CONSTRUCTION OF NEW MUNICIPAL SOFTBALL PARK REBID

PROJECT NO.: 08-18-C28-608

A D D E N D U M NO. 1

ADDENDUM No 1
SOFTBALL FIELD FACILITIES
MUNICIPAL PARK
McALLEN, TEXAS

Project No.:	33348.001
Issued:	07/11/2018
Drawn By:	G.Q.
Checked By:	B.S.
Scale:	AS SHOWN
Sheet Title	EXT. ELEVATIONS & ROOF PLAN

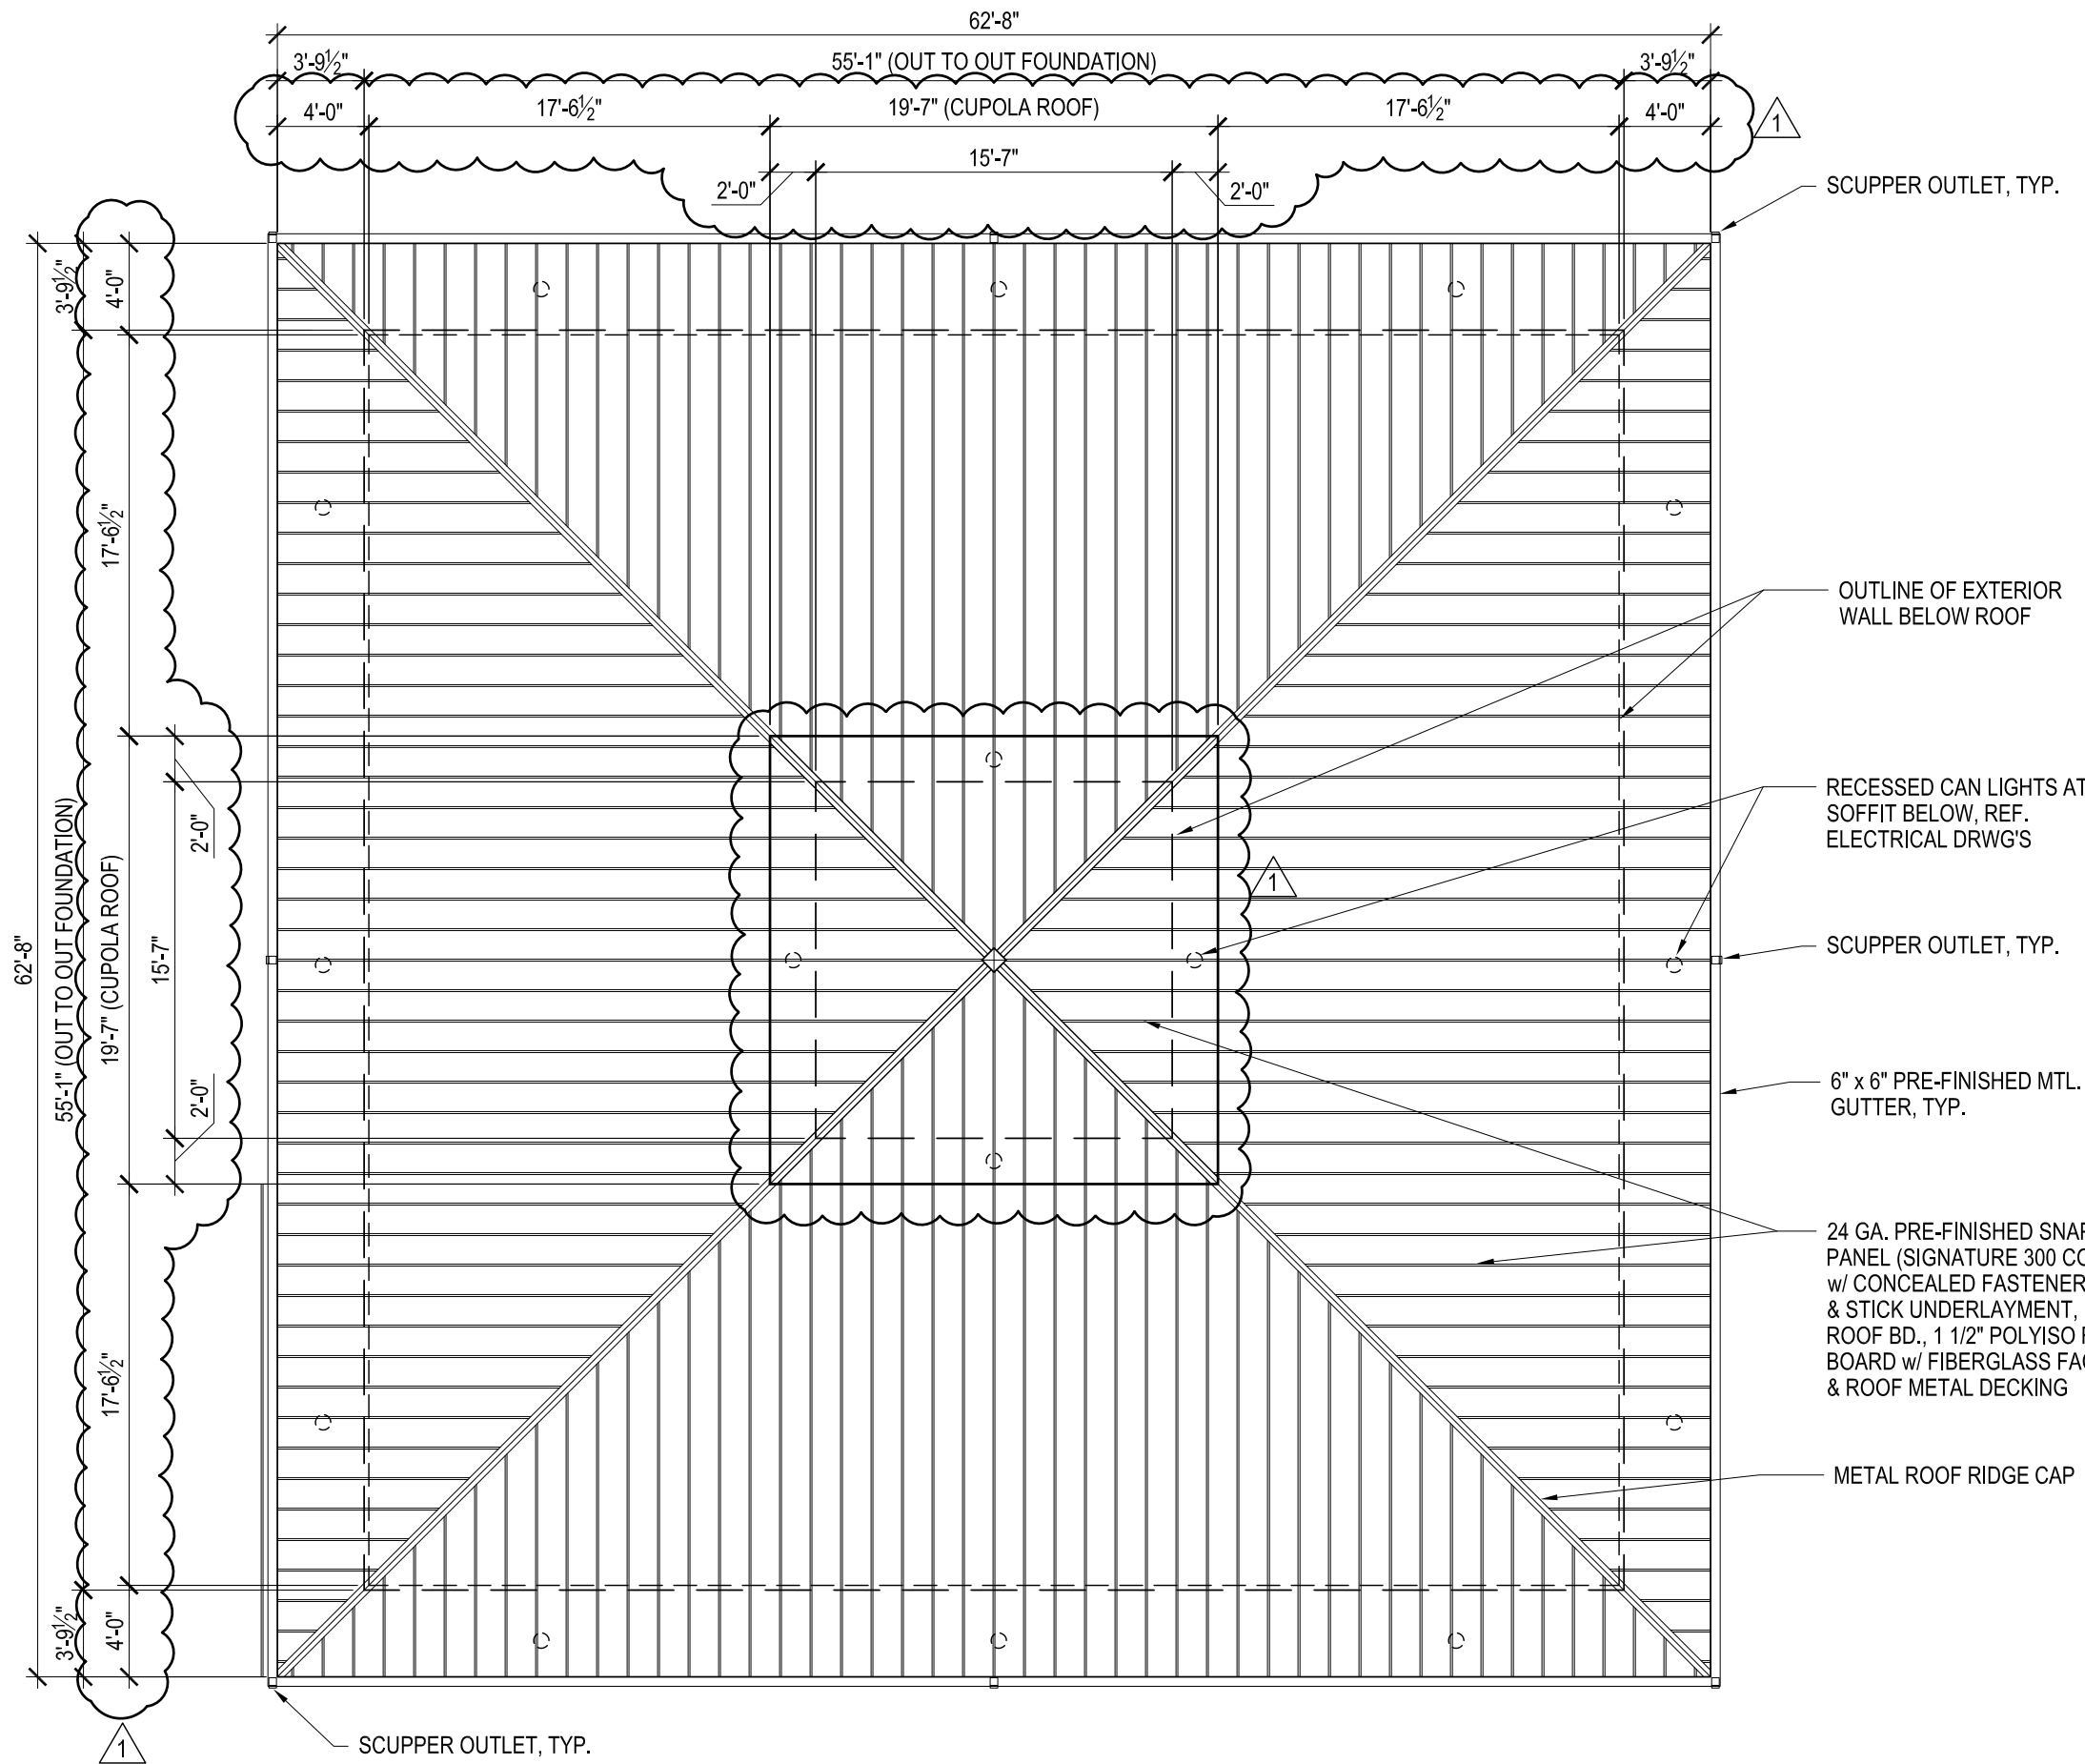
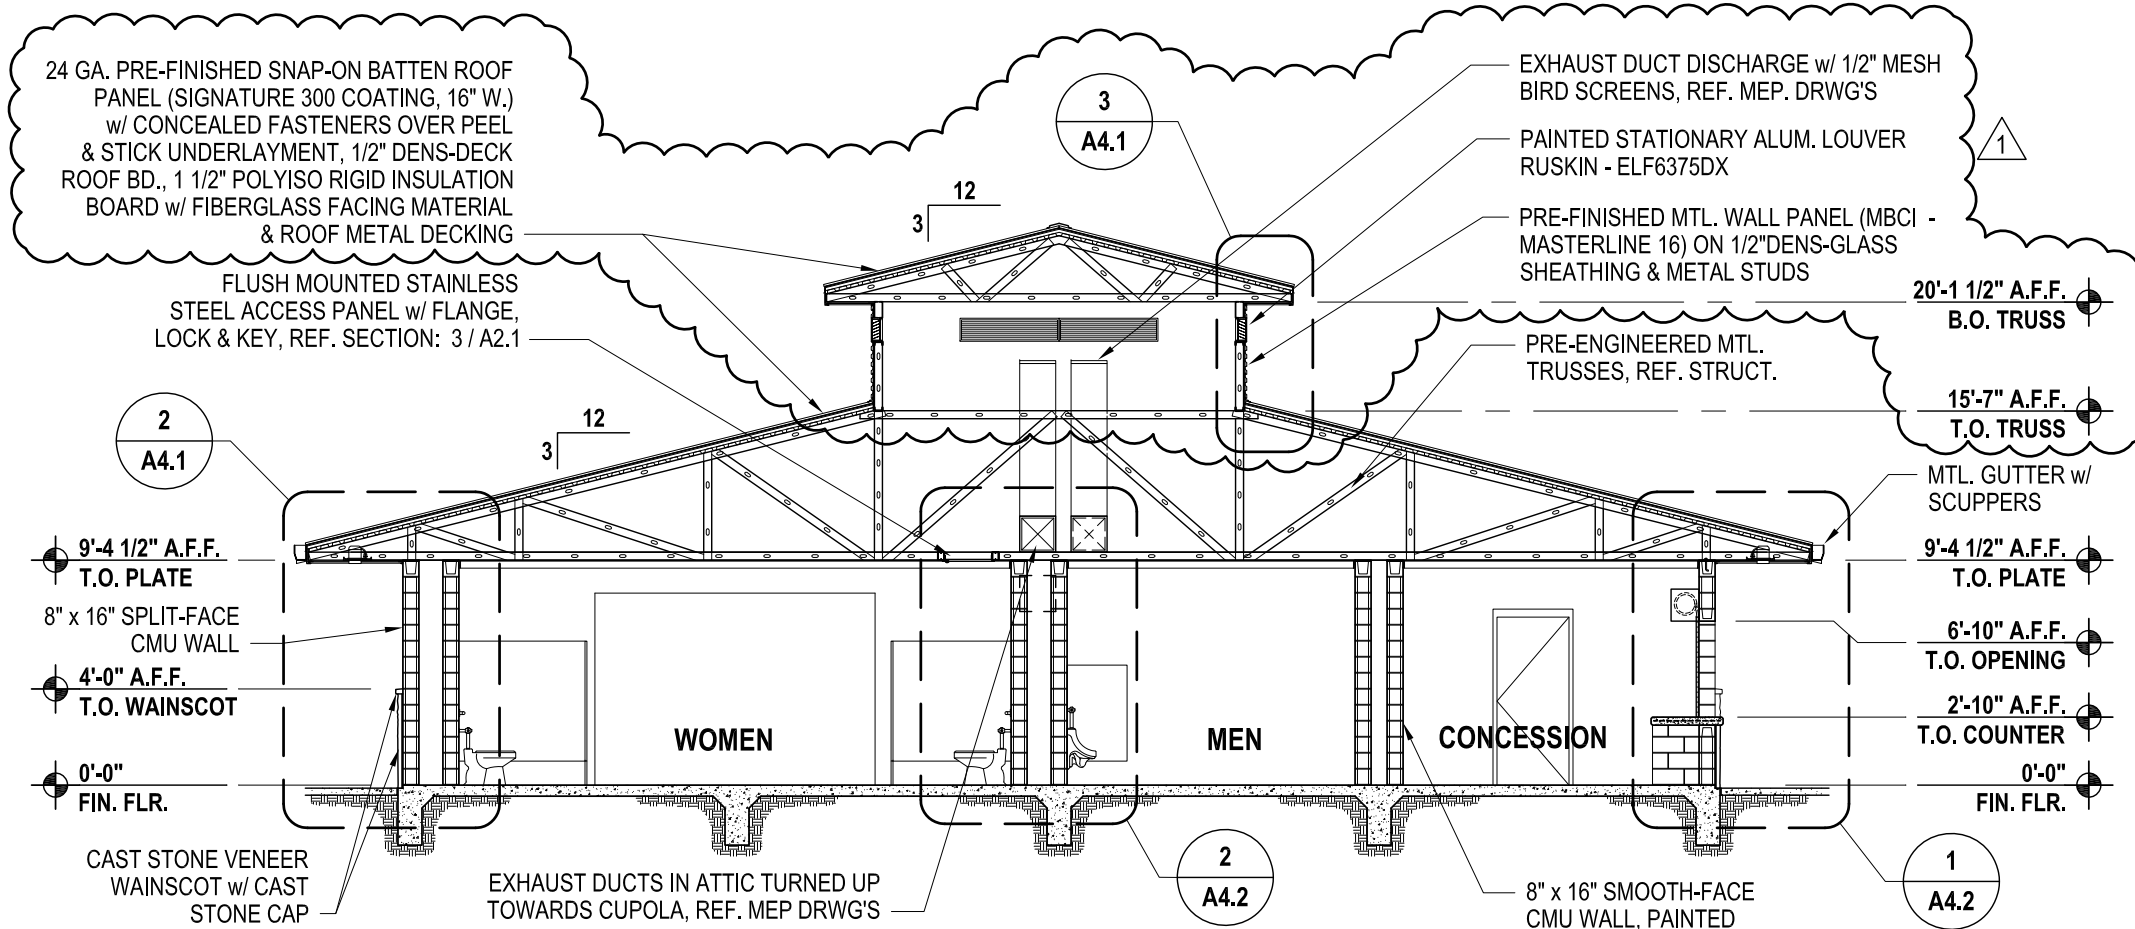
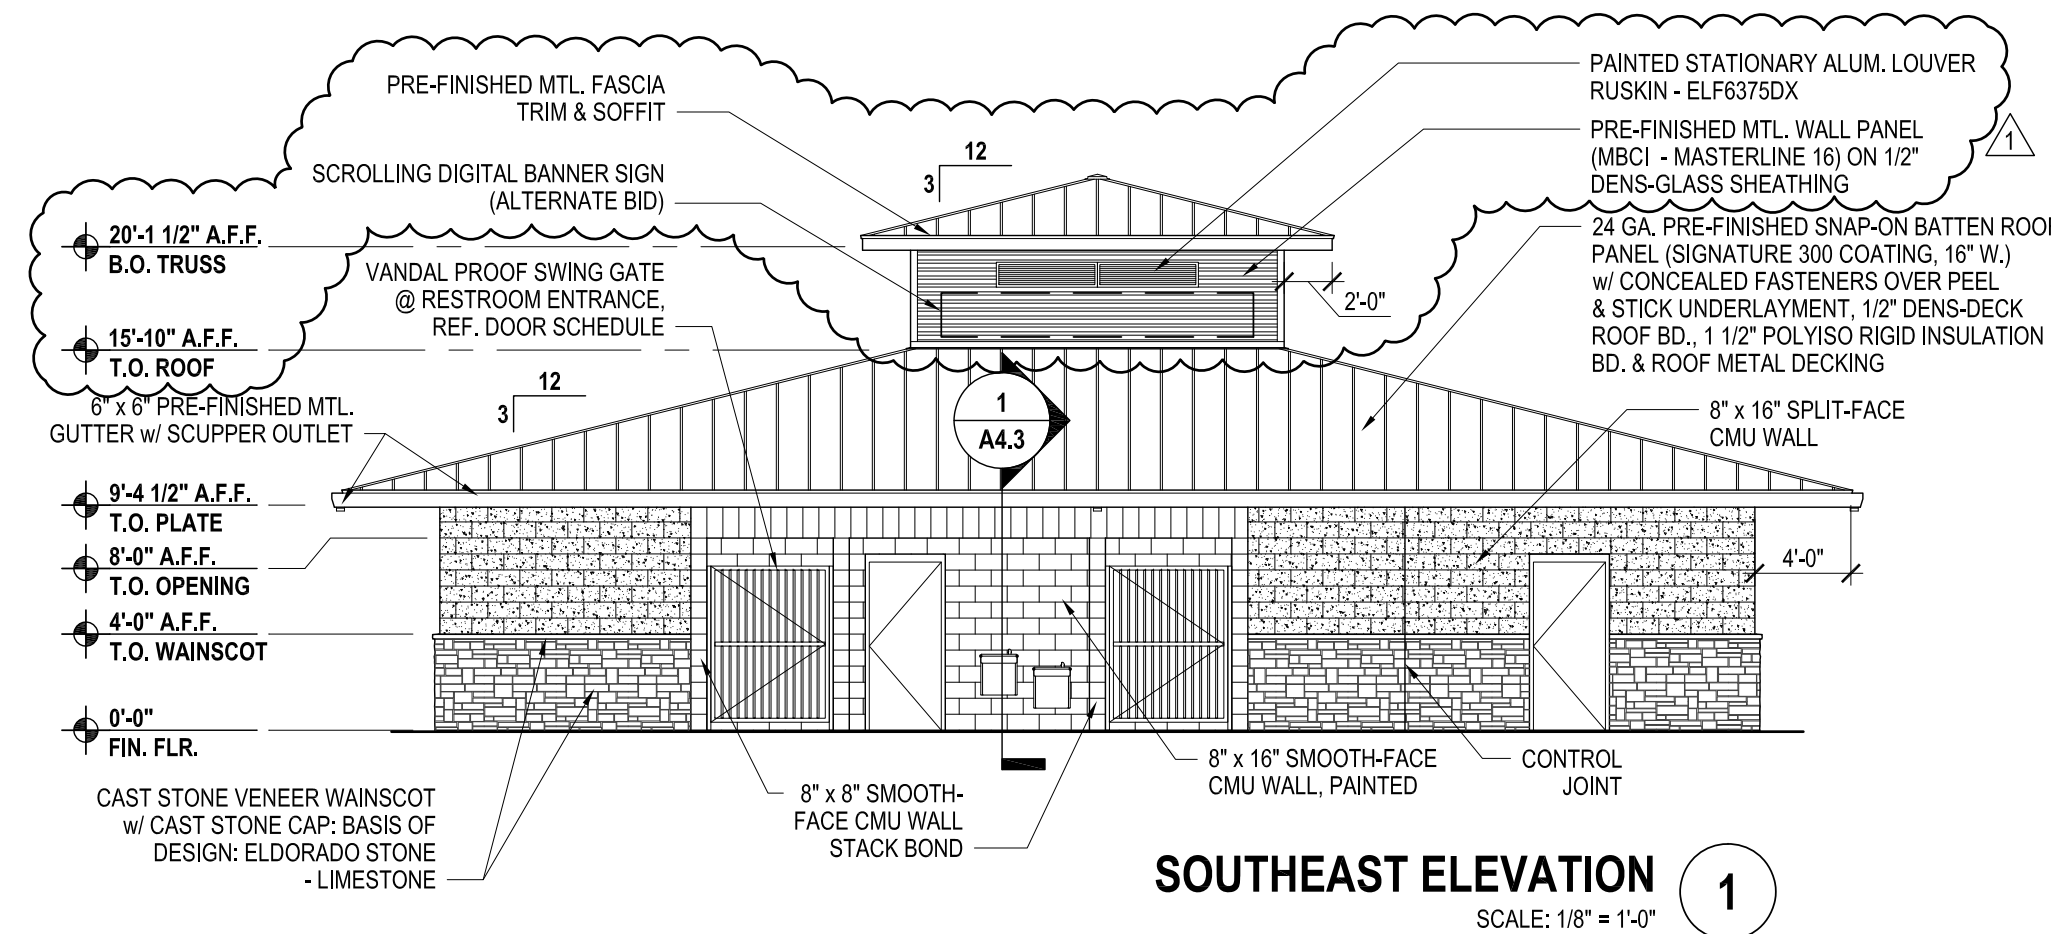
- A2.1 Added outline of Cupola wall above. Added RCP key note #7 & revised key note #8.
- A2.2 Relocated ADA urinal, added ADA notes & dimensions.
- A2.3 Relocated ADA urinal, added ADA notes & dimensions.
- A3.1 Added Cupola & material call outs.
- A4.1 Added wall section at Cupola. Added ADA notes & dimensions.
- A4.2 Added wall detail at Cupola.
